# Wollongong Local Planning Panel Assessment Report | 2 July 2020

<b>WLPP No.</b>	Item 3
<b>DA No.</b>	DA-2019/1008
<b>Proposal</b>	Residential - demolition of existing structures and the construction of and eight (8) storey residential flat building
<b>Property</b>	1 Smith Street, WOLLONGONG
<b>Applicant</b>	ADM Architects
<b>Responsible Team</b>	Development Assessment and Certification - City Centre Team (NL)

## ASSESSMENT REPORT AND RECOMMENDATION

Views to site from nearby locations (current vs proposed)

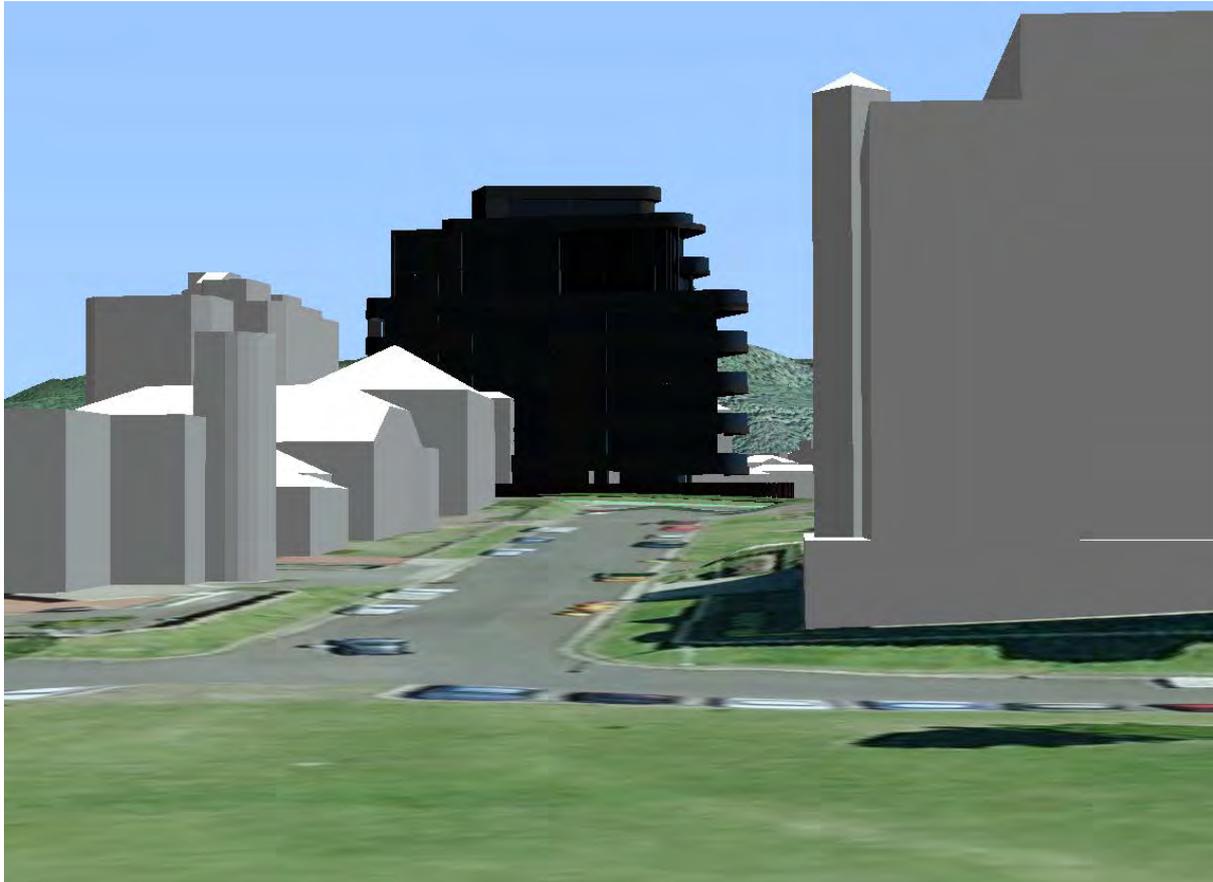
Concern	Comment
<p>The proposal will adversely impact on the view from Lang Park looking west along Hinton Street.</p>	<p>A representation of the impact of the proposal on this view has been provided using Council's 3D software model in the Council report to the Panel on the 7 April 2020 and similarly undertaken for the revised plans (see Figure 3).</p> <p>It is considered this is sufficient to understand the impacts to views toward the escarpment resulting from the proposal.</p> <p>The building will clearly obscure Mount Keira and the escarpment however this is not identified as a key view corridor under section 3.10 of Chapter D13. Additionally, in order to preserve a view of Mount Keira and the escarpment along that corridor would require a building of only approximately 5 storeys. This is not considered a reasonable proposition in consideration of the LEP height limits for the site.</p>

With regard to the photomontages, a representation of that view using Council's 3D software model was included in the Council report to the Panel on the 7 April 2020 and similarly undertaken for the revised plans (see Figure 3). Whilst this does not include the same detail as the other photomontages, it is considered sufficient to understand the impacts to views toward the escarpment. The building will clearly obscure Mount Keira and the escarpment. In order to preserve a view of Mount Keira and the escarpment along that corridor the building on the site would have to be limited to only

**Figure 7: Approximate location of 24m width**

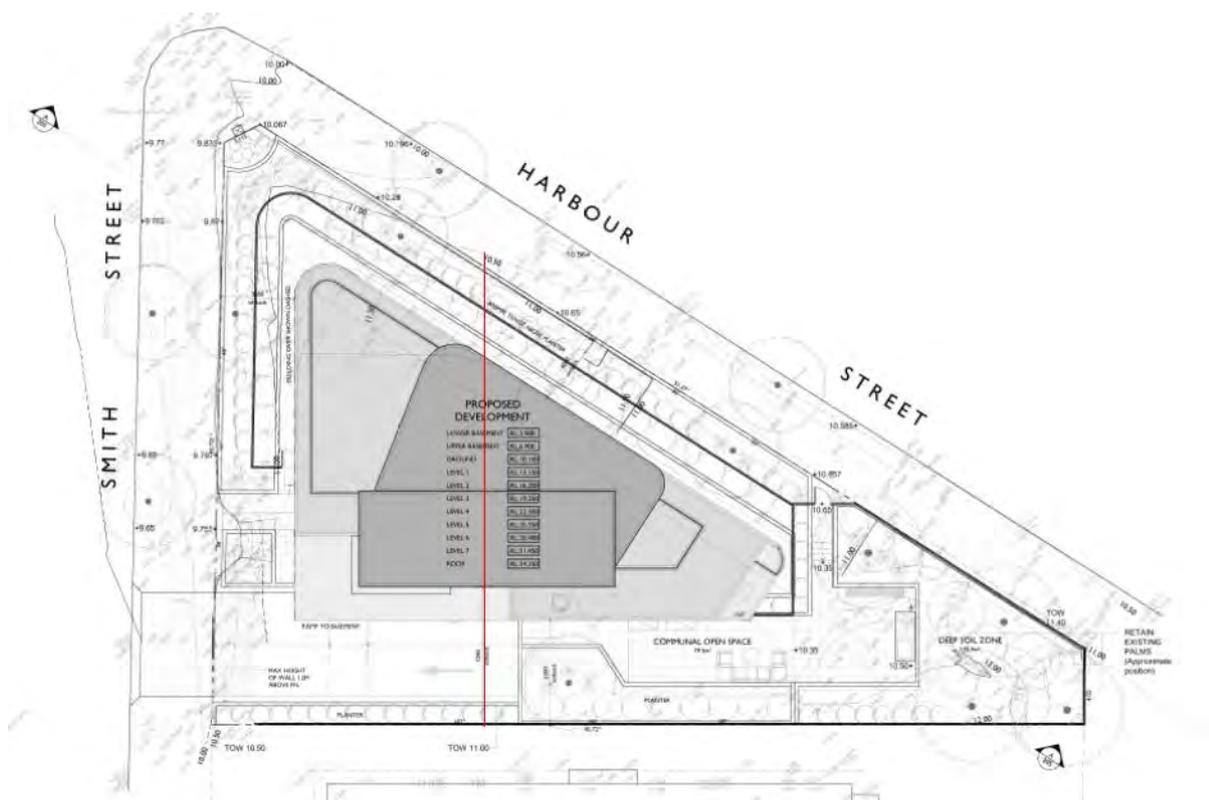
The site area means the area of any land on which development is or is to be carried out. The land may include the whole or part of one lot, or more than one lot if they are contiguous to each other but does not include the area of any land on which development is not permitted to be carried out under this Plan. The lot is triangular in shape and the building footprint is part located in an area of the site where the minimum dimension is less than 24m as illustrated at Figure 7 below.

A variation request has been submitted in accordance with clause 4.6 as discussed above.
